May 25, 2005

**Re: GE-Pittsfield/Housatonic River Site
Newell Street Area II (GECD450)
Final RD/RA Work Plan Addendum for Newell Street Area II**

ADDITIONAL AREA PROPOSED FOR NATURAL RESOURCE RESTORATION/ENHANCEMENT

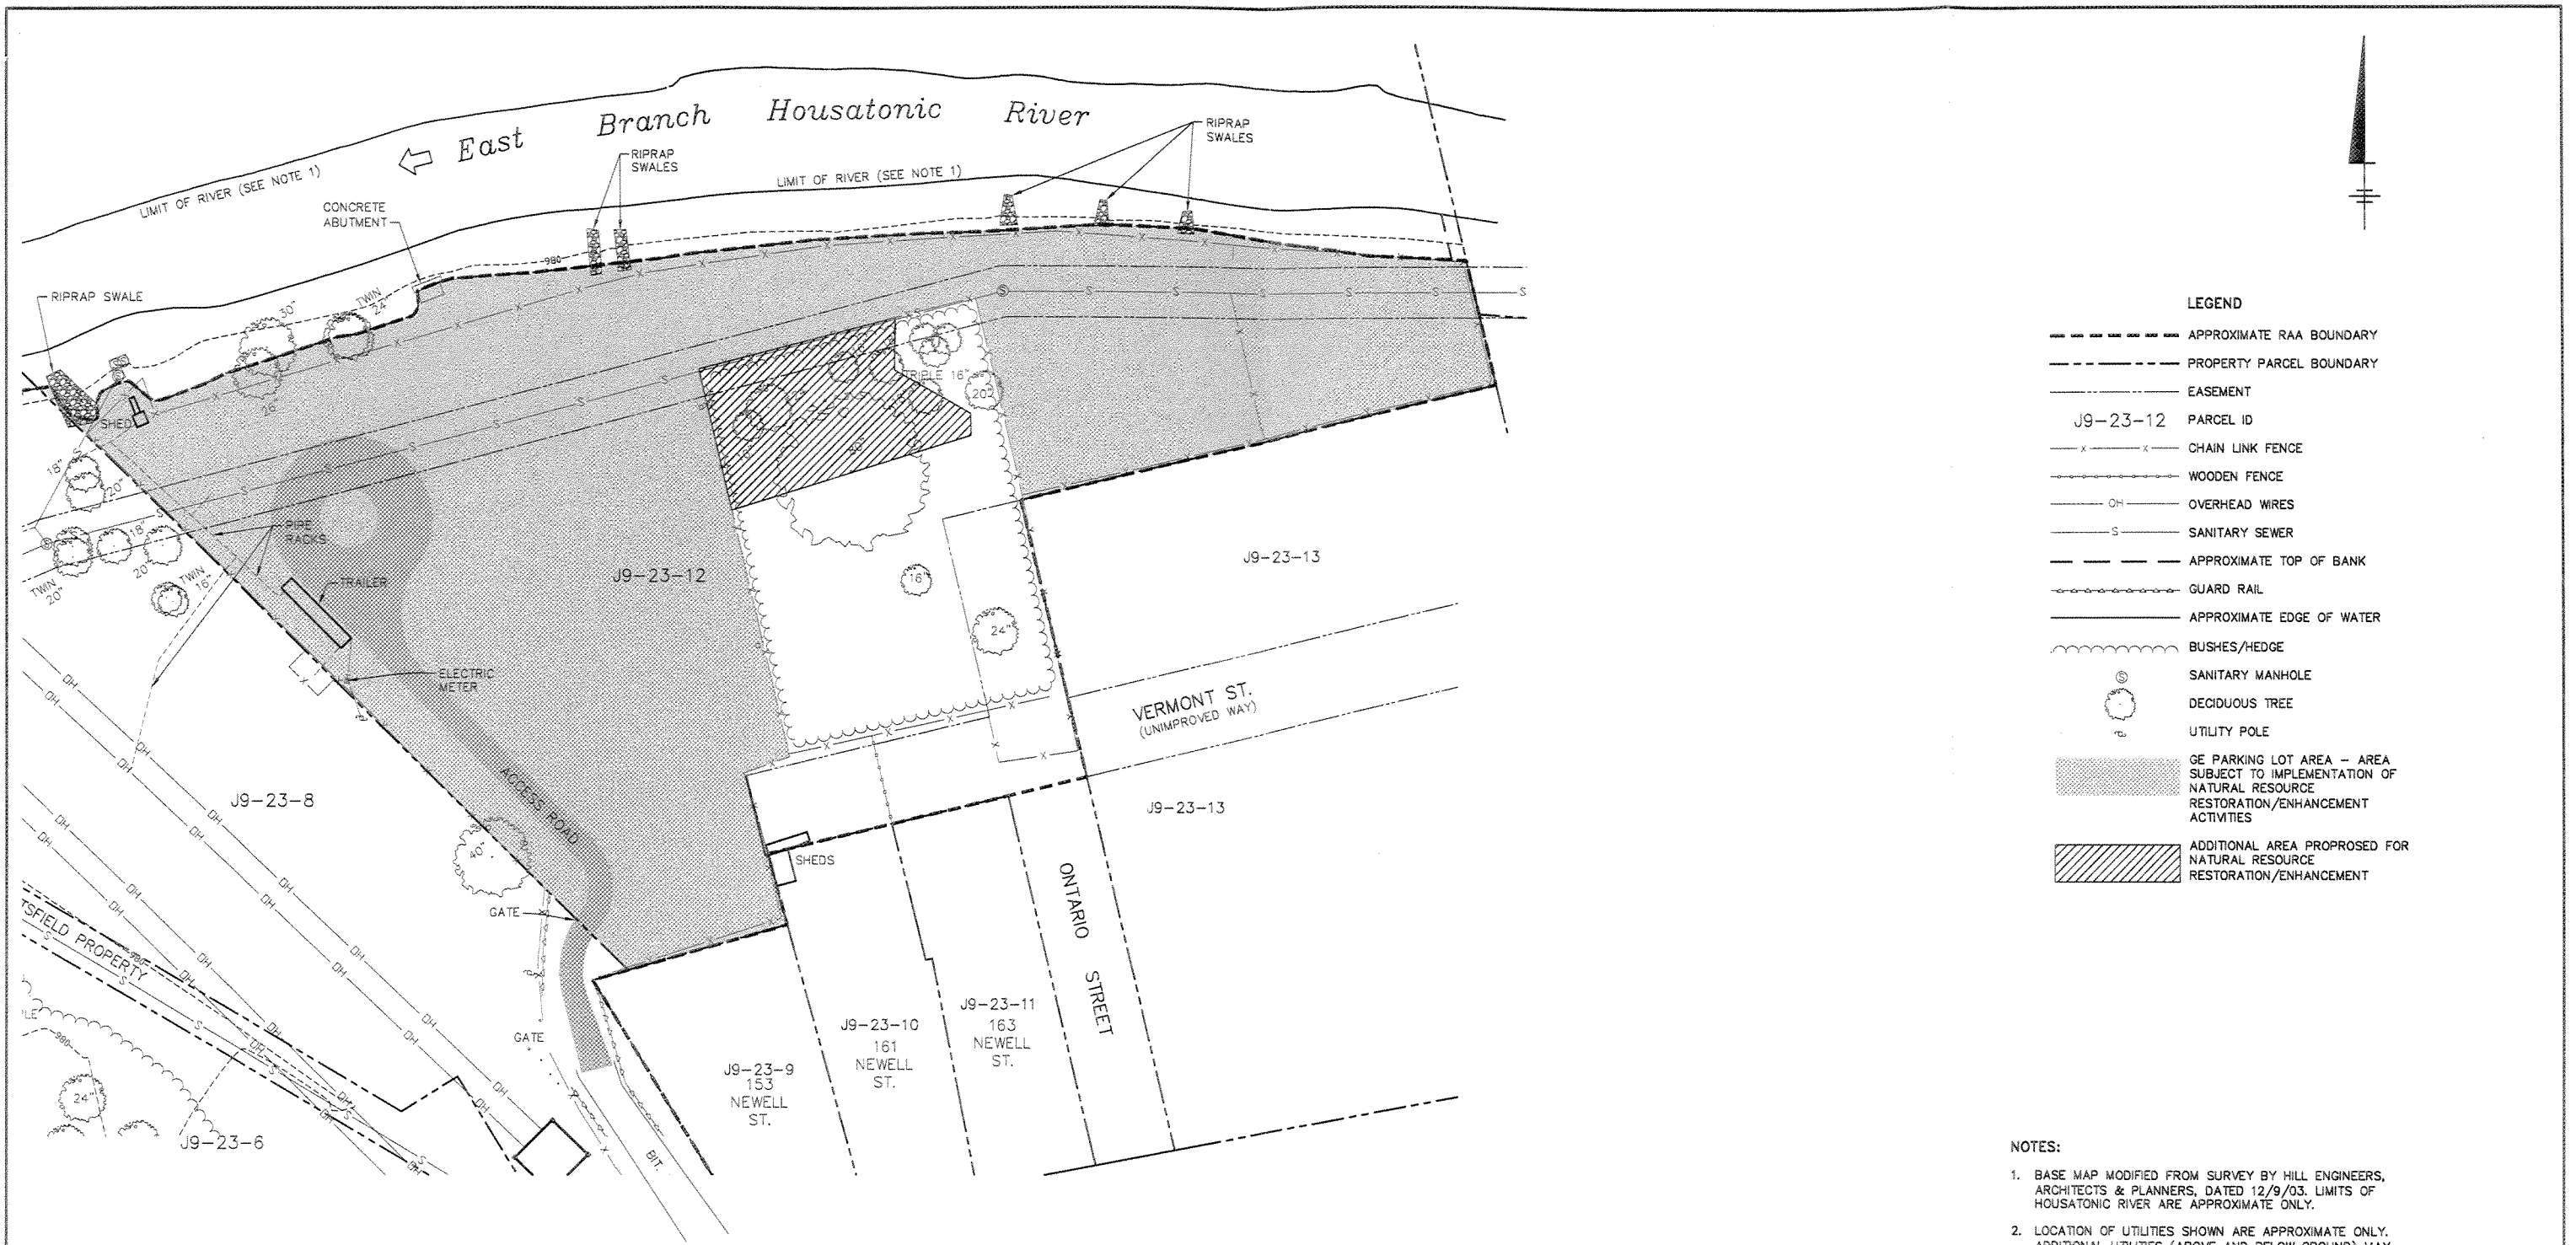
- *Trustee Comment: The Trustees concur with this justification. However, the proposed access road on parcel J9-12-23 will diminish the natural resource restoration/enhancement due to the loss of required grassland habitat. The Trustees therefore require GE provide additional restoration/enhancement to compensate for the area lost. Such request is consistent with the Conceptual RD/RA, Page 3-15: ".... GE may discuss w/ EPA & Trustees the possibility of installing a paved or gravel engineered barrier in lieu of vegetative in a portion of the parking lot... . If so, GE would discuss conducting the planting that would have occurred be implemented in another portion."*

GE Response – In accordance with the response GE provided in its April 29, 2005 letter to the Trustees, GE will provide additional habitat area to offset the area to be occupied by the paved access road. The area of the paved access road is approximately 7,400 square feet (sq. ft.). GE will provide compensation for a portion of the wooded area within Parcel J9-23-12 adjacent to the Newell Street parking lot area, as shown in attached Technical Drawing 1. Natural resource restoration/enhancement activities within this area will be consistent with those specified in the Final RD/RA Work Plan.
